## W5300 Errata Sheet

Ver 1.1.0 (AUG. 19, 2008)	First release (erratum 1, 2, 3)
Ver 1.2.0 (FEB. 23, 2012)	Add Erratum 4, 5
	Change the Errata sheet form
	(Match with W3150A+ / W5100 Errata sheet.)
Ver 1.2.1(MAR. 23, 2012)	Add a solution for erratum 4,5

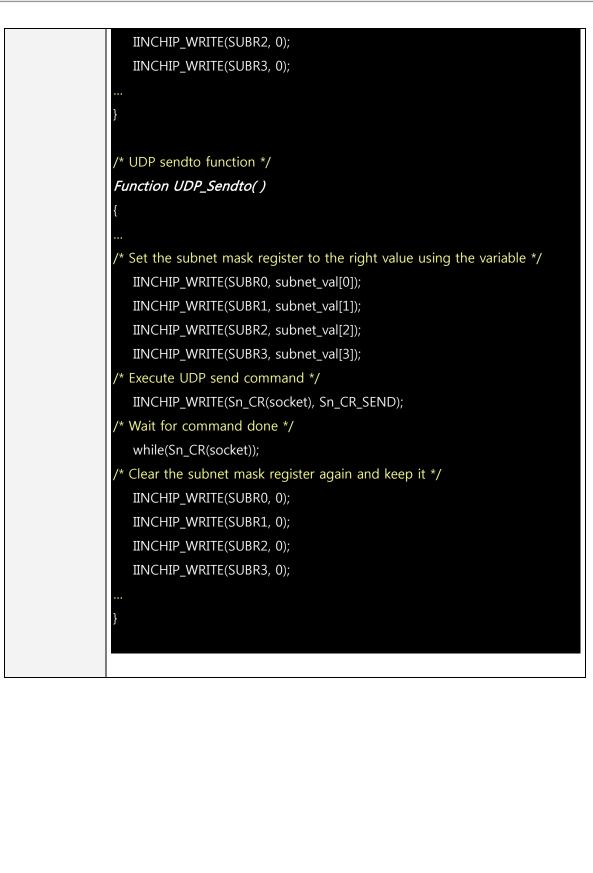
Erratum 4				
Phenomenon	The W5300 replies with gatewa	ay IP address for the ARP request from		
	normal node which has "0.0.0.0	" IP address. But normally the W5300		
	should replies with target IP a	ddress "0.0.0.0" not the gateway II		
	address.			
Condition	Normal Node↔           IP: 0.0.0.0↔           SN: 255.255.255.0↔           Wrong Targe	Request <sup>12</sup> withe <sup>1</sup> et IP address: <b>192.168.1.254</b> <sup>12</sup> SN: 255.255.255.0e <sup>1</sup> GW: 192.168.1.254e <sup>1</sup> GW: 192.168.1.254e <sup>1</sup>		
	misunderstands the node locates	is subnet calculating logic. The W530 s other sub-network when target ha 00 set the target IP to the gateway II ARP reply.		
	To avoid this erratum we must kee	ep the subnet mask register value to zero		
	except two cases which are "CC	NNECT" command in TCP and "SEND		
	command in UDP. Because only th	nese two cases are referring the subne

mask register and sending the ARP r	equest.		
		o "0.0.0.0" and keeping it but save th		
	C C	al variable when you initialize the W5300		
		n TCP or send command in UDP, set th		
	5	value using the variable before executin		
	6 6	one connect or send command, clears th		
Solution &	subnet mask register again to keep its value to "0.0.0.0"			
Recommendat	Before Applying (without solution)	After Applying (with solution)		
ion	W5300 Initialization	W5300 Initialization		
	Set GW : 192.168.1.254 Set IP : 192.168.1.2 Set SN: 255.255.255.0	Set GW: 192.168.1.254 Set IP: 192.168.1.2 Set SN: 0.0.0.0 & save the SN to global variable.		
		TCP Connect UDP Send		
	"E	t SN from global variable xecute connect command" ear SN : 0.0.00

Example pseudo code:
